Table 1. Plan/Policy Consistency of Proposed Active Transportation Facilities

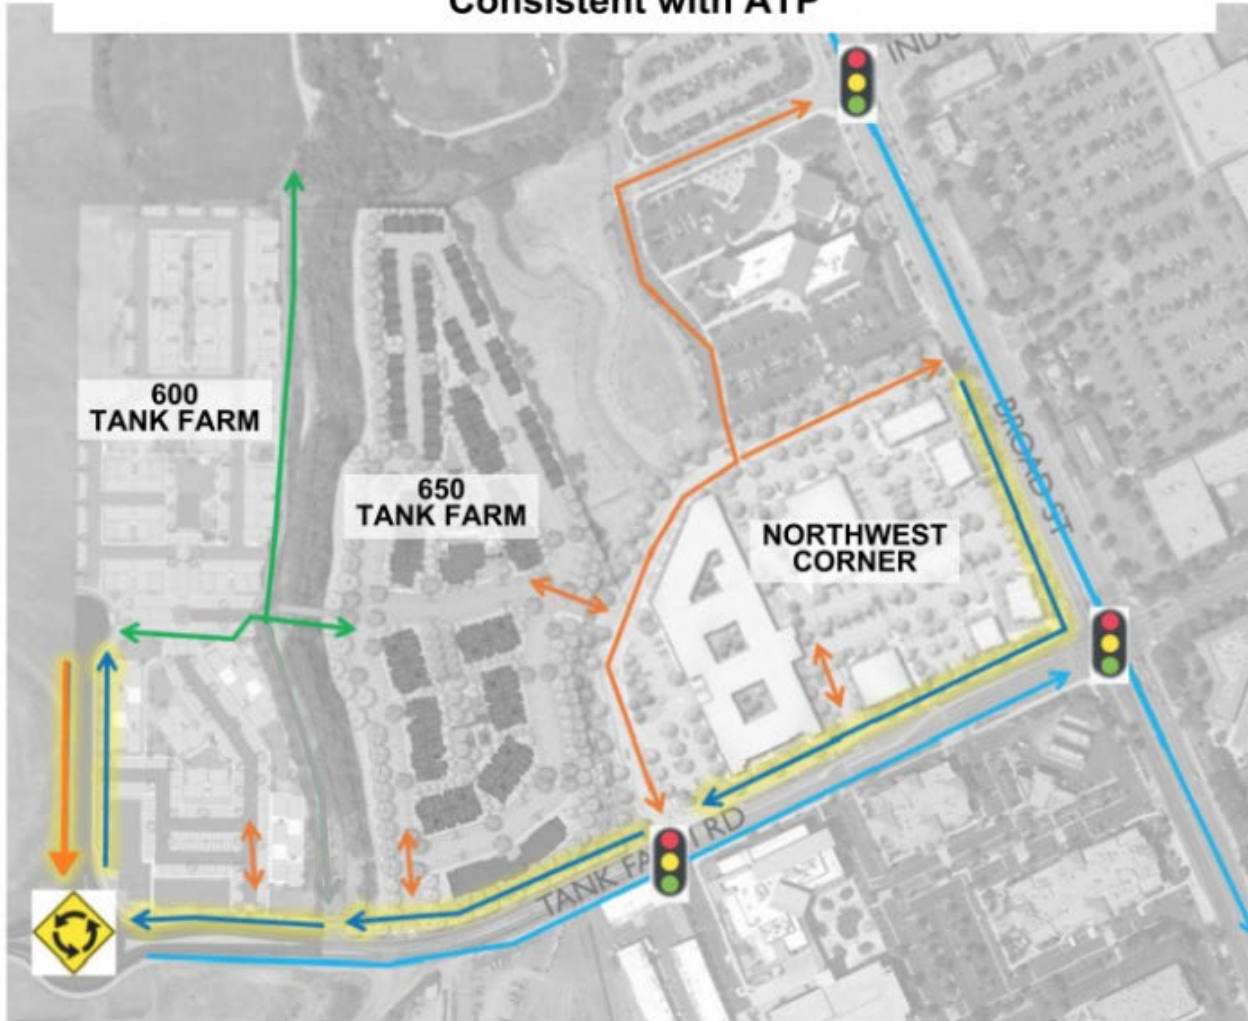
Issue/Facility	Adopted Plan/Policy	Originally Approved 600 Tank Farm Road Project (2022)	Modified 600 Tank Farm Road Project (2025)
Tank Farm/Santa Fe (West) Intersection Control	Future multi-lane roundabout (LUCE, AASP)	Design and construct north/west/east legs of multilane roundabout	<ul style="list-style-type: none"> • Construct interim unsignalized intersection • Prepare designs, dedicate on-site R/W and pay fair share fees towards future roundabout to be constructed by others.
Nearest Low-Stress Bike/Ped Crossing of Tank Farm Rd to 600 Tank Farm Site	Future crossings at Tank Farm/Santa Fe Roundabout and at Tank Farm/Mindbody signal (ATP, AASP)	Crossings at new Tank Farm/Santa Fe Roundabout and at Tank Farm/Mindbody signal	<ul style="list-style-type: none"> • Designated crossings at Tank Farm/Mindbody signal only with initial project • Future crossings at Tank Farm/Santa Fe Roundabout when constructed by others

Santa Fe (West) Bicycle and Pedestrian Facilities	Future one-way protected bike lanes & sidewalks on each side of road (ATP)	<ul style="list-style-type: none"> • Construct elevated one-way (NB) protected bike lane and sidewalk on east side along project frontage. • Future bike lane and sidewalk on west side by others. 	<ul style="list-style-type: none"> • Construct elevated two-way shared-use path on east side along project frontage. • Potential to convert two-way path to separate one-way (NB) bike lane and sidewalk in future.
Tank Farm Rd Bicycle and Pedestrian Facilities			
Segment 1: West of Santa Fe	Future two-way shared-use paths on north and south sides of street between Innovation Way and Santa Fe (AASP, ATP)	<ul style="list-style-type: none"> • Project applicant to prepare 65%-level designs and environmental studies for future path on north side of street west of Santa Fe • Pay fair share fees towards future construction of path by others 	Same as 2022 proposal

Segment 2: Santa Fe to Mindbody	Future one-way protected bike lanes & sidewalks on each side of street (ATP)	<ul style="list-style-type: none"> • Construct elevated one-way (WB) protected bike lane and sidewalk on north side along project frontage • Future protected EB bike lane and sidewalk on south side by others 	<ul style="list-style-type: none"> • Construct elevated two-way shared-use path on north side along project frontage between Santa Fe and Mindbody. • Potential to convert two-way path to separate one-way (WB) bike lane and sidewalk in future.
Segment 3: Mindbody to Broad	Future one-way protected bike lanes & sidewalks on each side of street (ATP)	Construct temp asphalt sidewalk on north side from Mindbody to Broad if permanent protected bike lane and sidewalks per ATP have not yet been constructed by approved developments at 650 & 660 Tank Farm	Same as 2022 proposal
Plan/Policy Source LUCE – General Plan Land Use & Circulation Element; AASP – Airport Area Specific Plan; ATP – Active Transportation Plan
